# State Significant Development Application - SSD 6673 and Concept Plan Modification MP 06\_0171(MOD 10) Response to Submissions/Preferred Project

## Block 4N, Central Park

### Mixed Use Residential Development

Submitted to Department of Planning and Environment  
On Behalf of Central Park JV No 2

**Figure 1 – Central Park Avenue Drop Off/Pick Up**  
Source: Foster + Partners and JBA

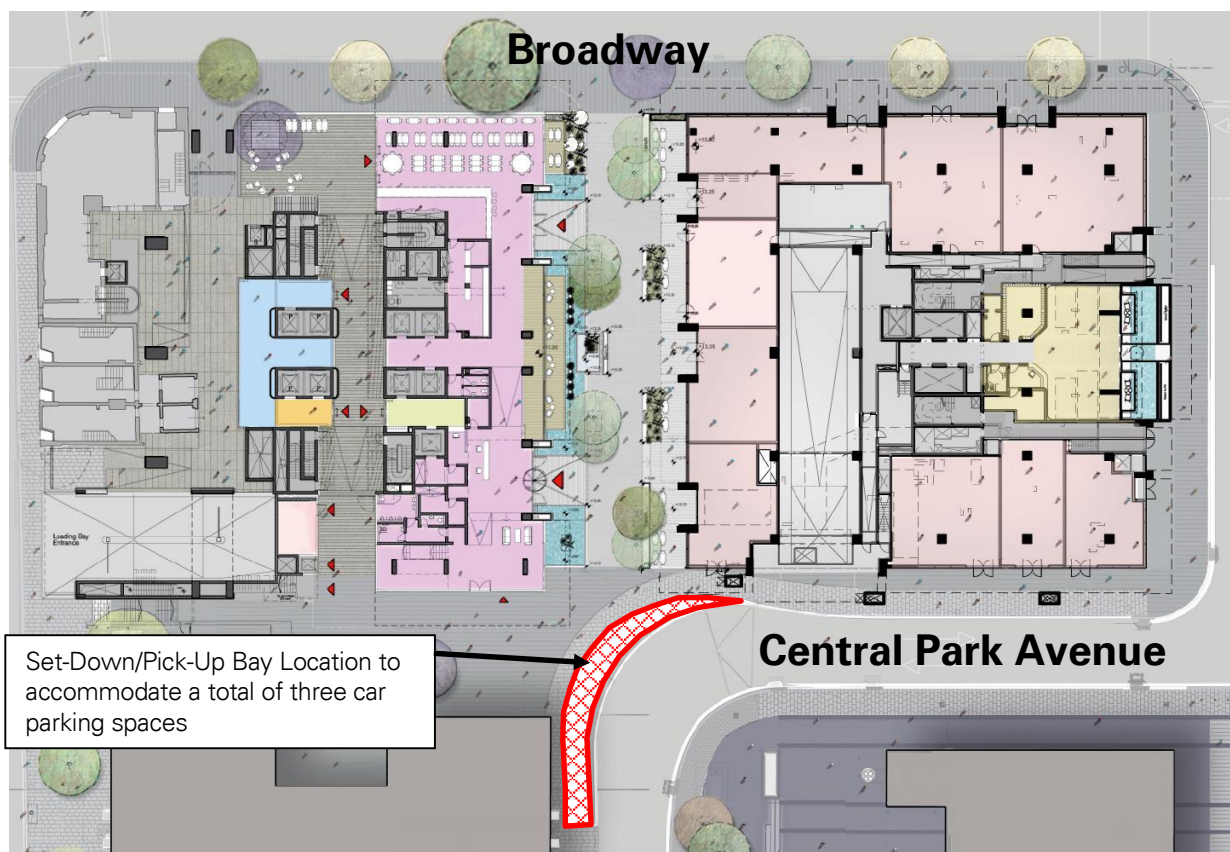
Both the DPE and CoS have requested further consideration be given to options to provide additional drop-off/pick-up spaces on the site.

In response, the proponent and civil engineer have reviewed the design of Central Park Avenue, namely the north-western corner between Block 4N and 1, exploring the options for the inclusion of a lay back and pick-up/drop-off bays. The revised Central Park Avenue Plan is provided at **Appendix I**.

The north western curb line on this corner is proposed to be amended to allow for vehicle set-down and pick-up spaces including taxis, buses, and private vehicles. This space is equivalent to three car parking spaces, with an approximate length of 21m. In addition to the kerb alignment amendments on the corner, revised street signage is also proposed adjacent to the existing approved parking spaces along the western side of Central Park Avenue. The proposed signage amendments to these three parking bays will provide additional drop-off bays during peak mornings and afternoons.

**Figure 2 – Location and Access path to staff bicycle parking Basement B1**  
*Source: PTW + JBA*

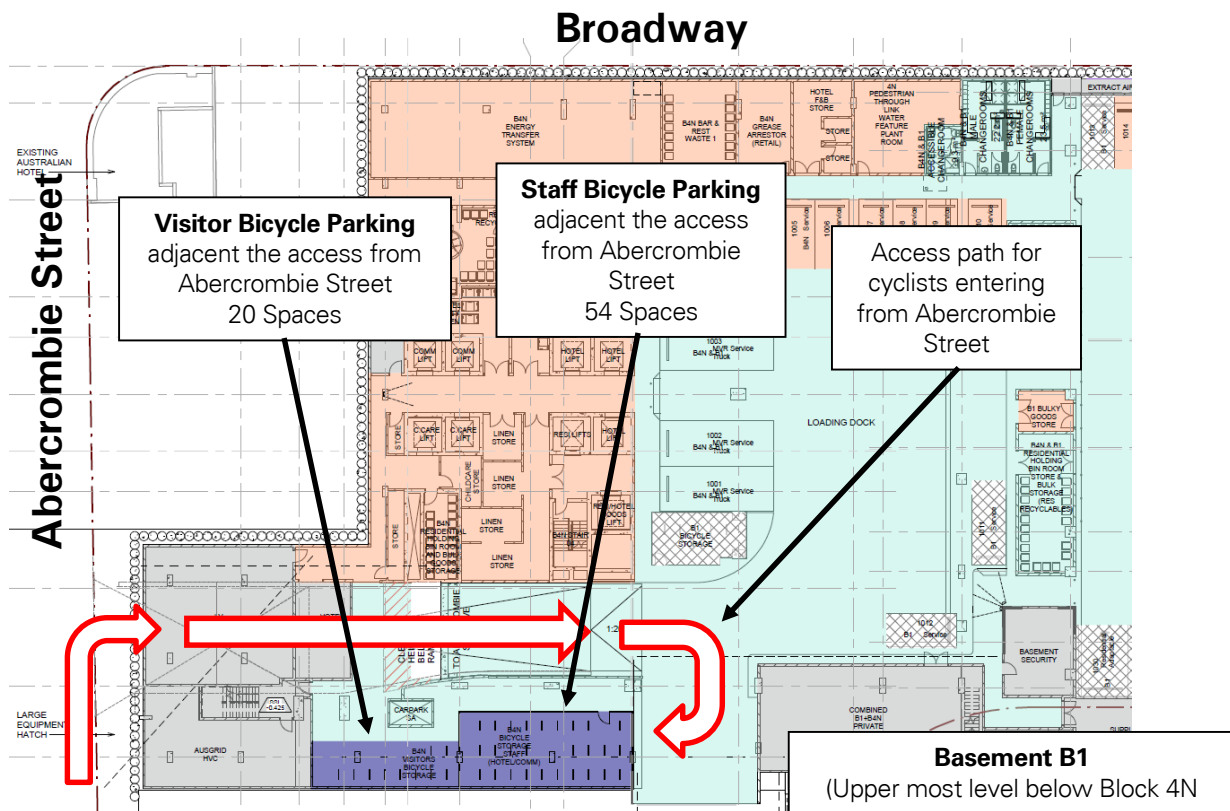
The DPE requested the location of visitor and staff bicycle parking be reviewed in order to ensure they are suitable located and designed.

TfNSW commented that bicycle parking for staff be provided at the upper level basement, not located within or near any reverse manoeuvre paths of vehicles, and for visitor parking to preferably be placed at ground level in accessible and visible areas.

Staff and visitor bicycle parking is located on the upper most level of the basement (basement Level B1), with access from the Abercrombie Street ramp. As shown on Basement Level 1 plan (**Appendix B** and **Figure 2**), the staff parking secure storage area, and visitor parking spaces are located directly adjacent the access ramp, removed from vehicle access pathways, providing a safe area for cyclists. The location and design of the staff bicycle parking (in one secure location), and visitor bicycle parking on Basement Level 1 is therefore considered to be suitable.

As noted above in **Section 2.3**, and **Figure 2**, the staff bicycle parking area has been well located at the upper most level of the basement, accessed from Abercrombie Street. As shown in **Figure 2**, this area is located outside of the line of any vehicle movements, and is not located adjacent any areas of reverse manoeuvre paths.
